ADDENDUM NO. 2

October 27, 2022

Carey Ridge Elementary Addition & Renovation
16231 Carey Road
Westfield, IN 46074

1 PARTIAL BUILDING SECTION
A403 SCALE: 3/4" = 1'-0"

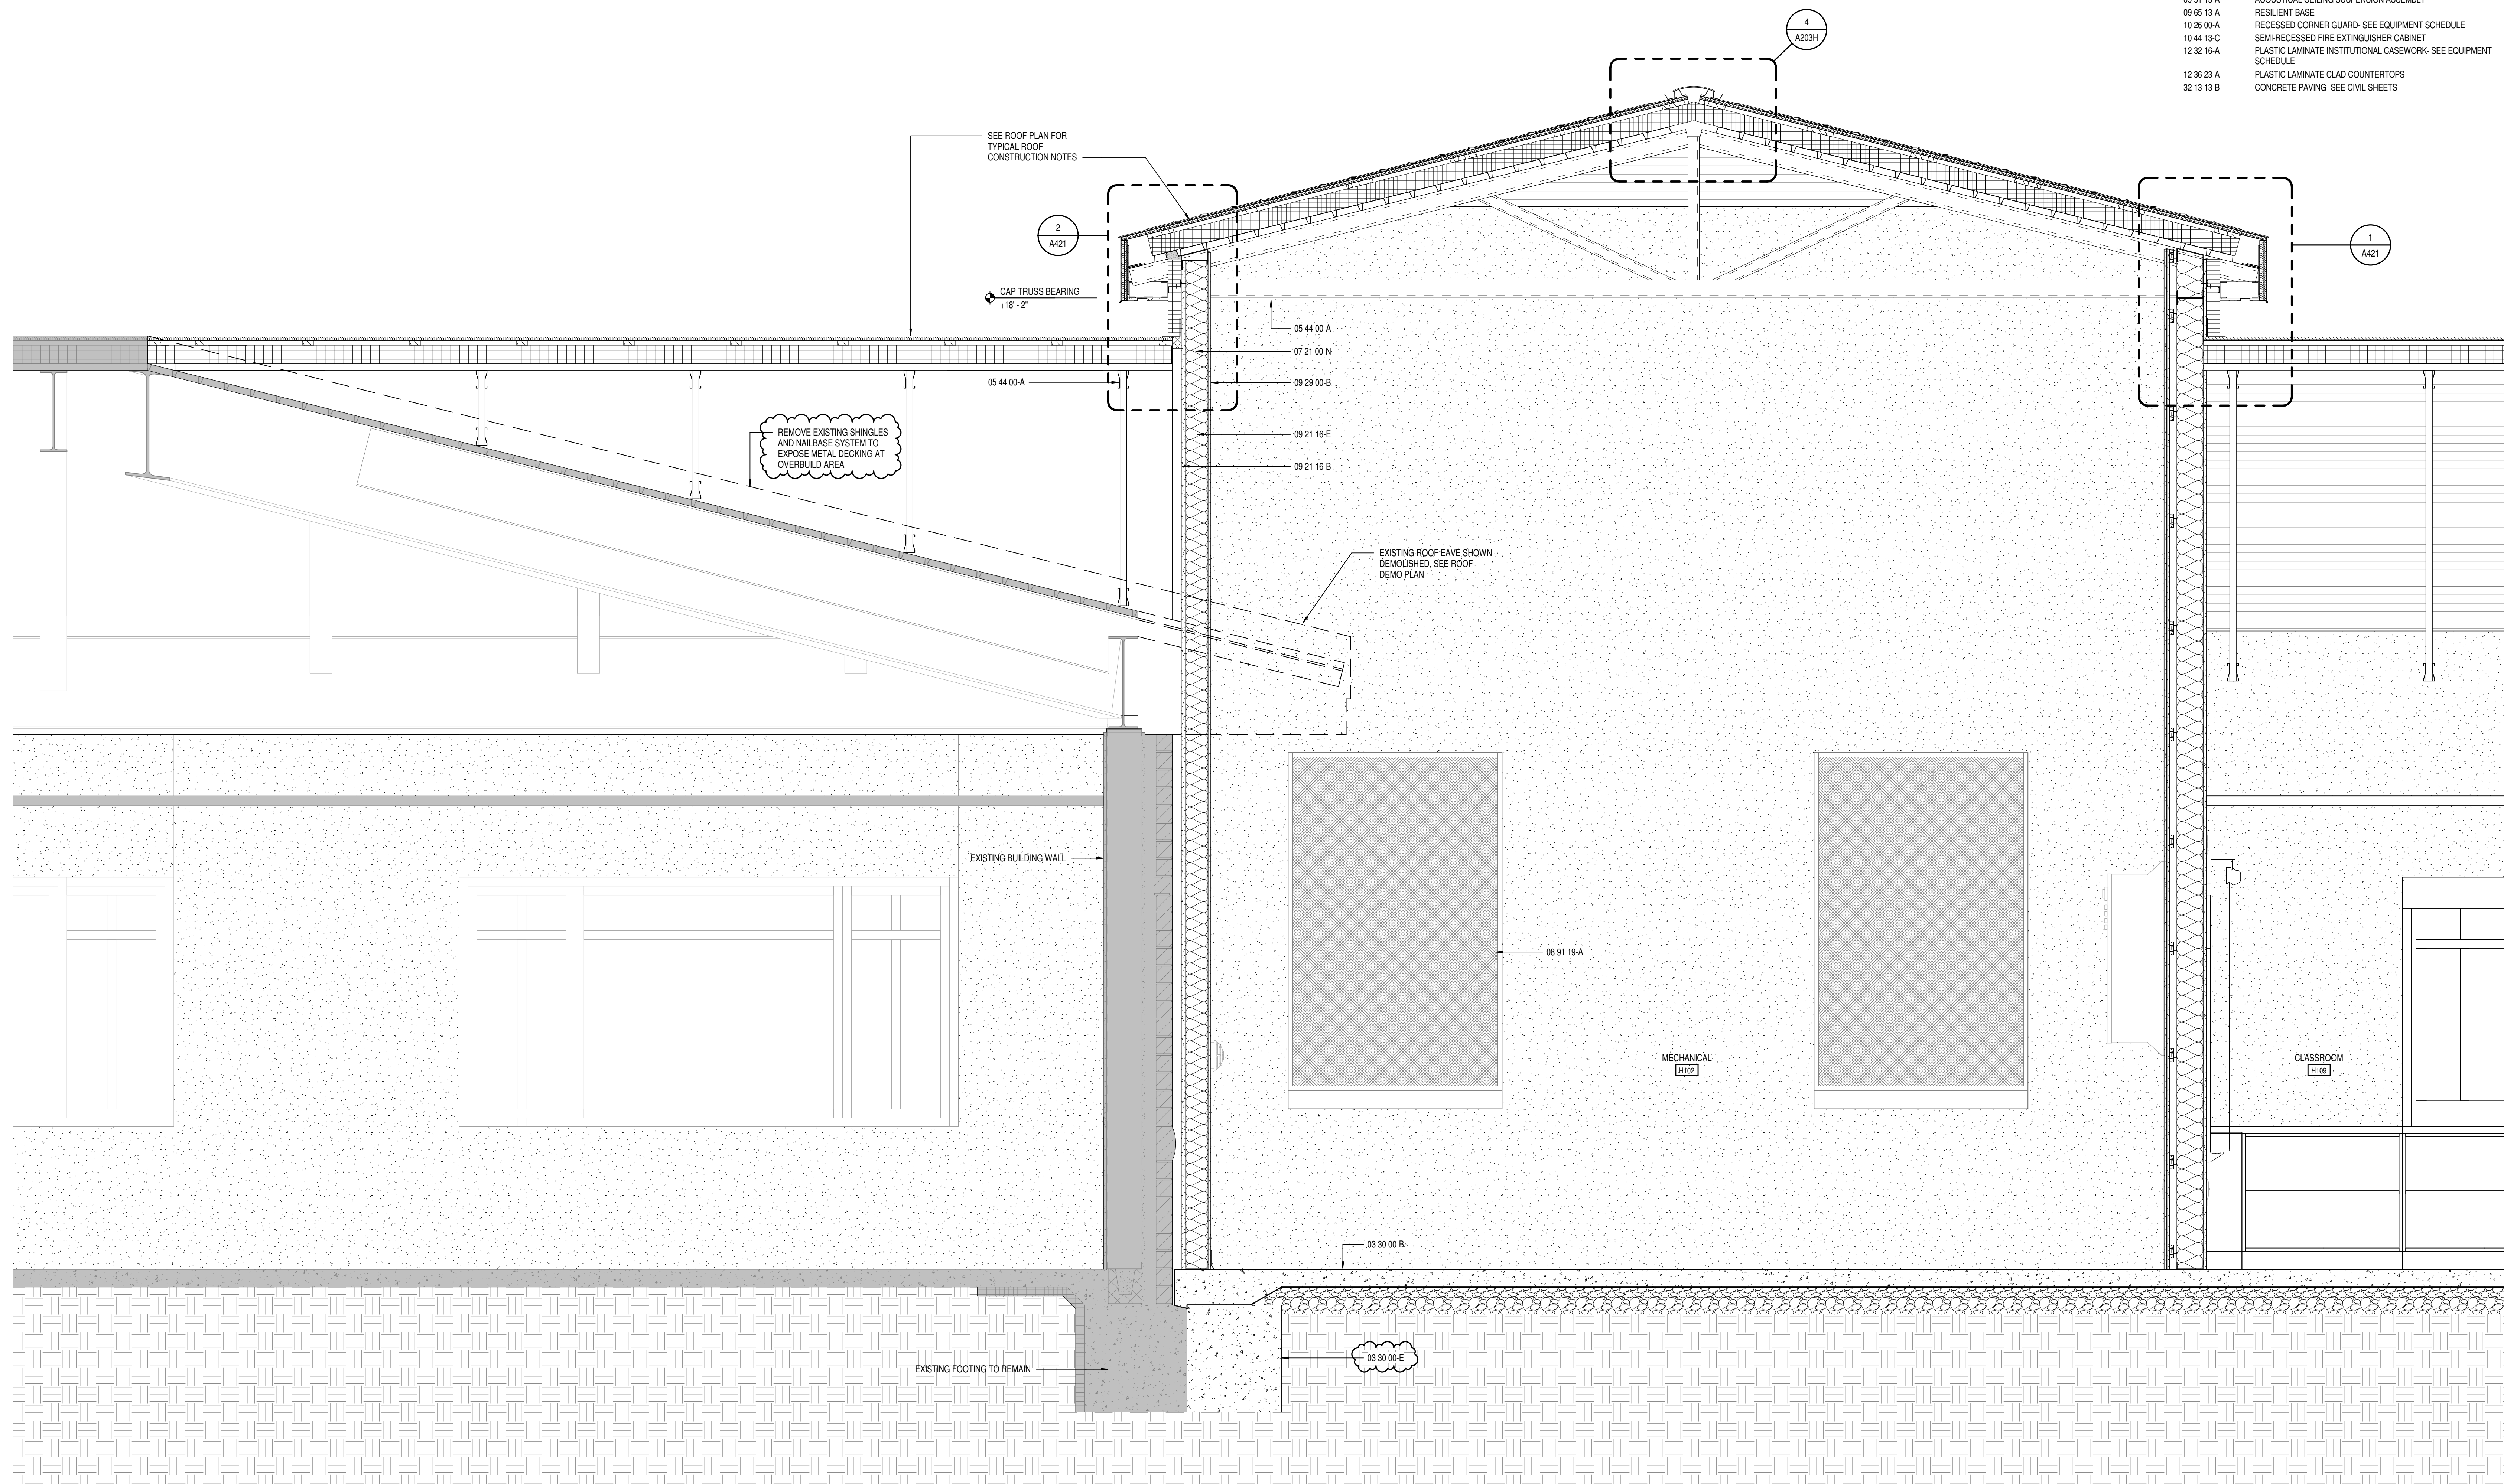
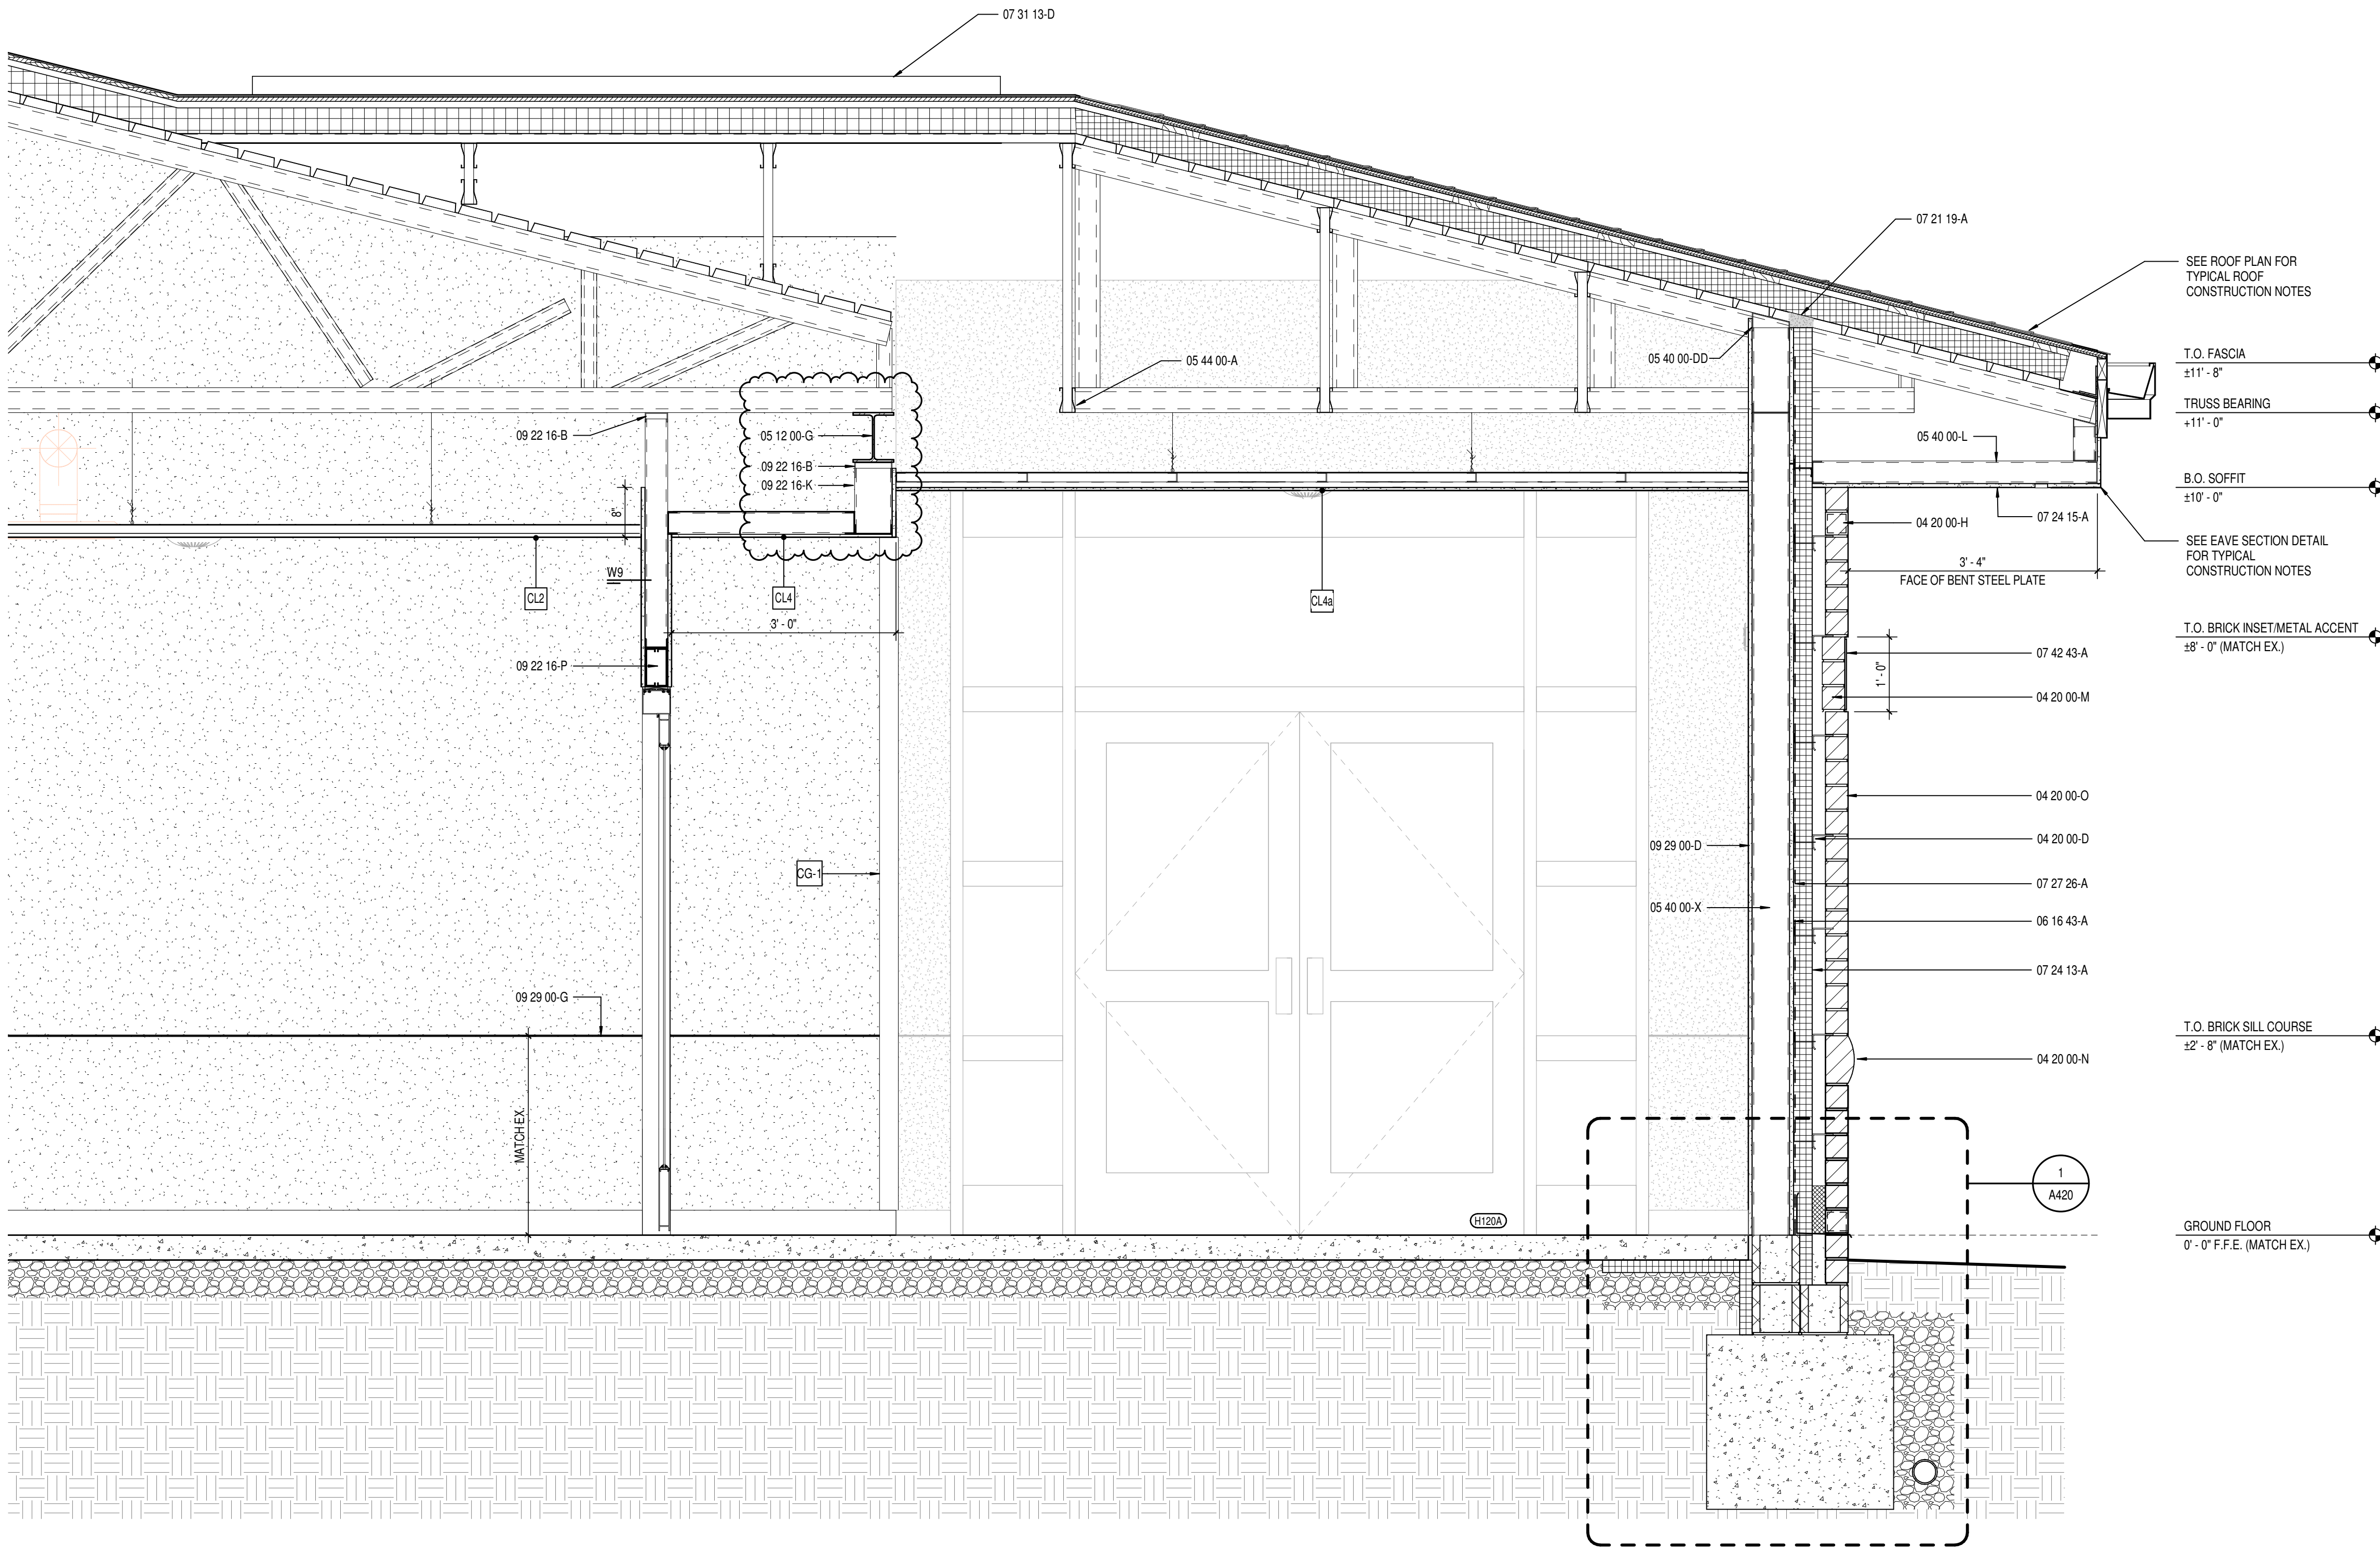
- A. Partial Building Section 1/A403
1. Removed keynote adding gypsum sheathing on overbuild end truss.
 2. Revised demolition note and linework related to existing hip roof and eave below new overbuild.
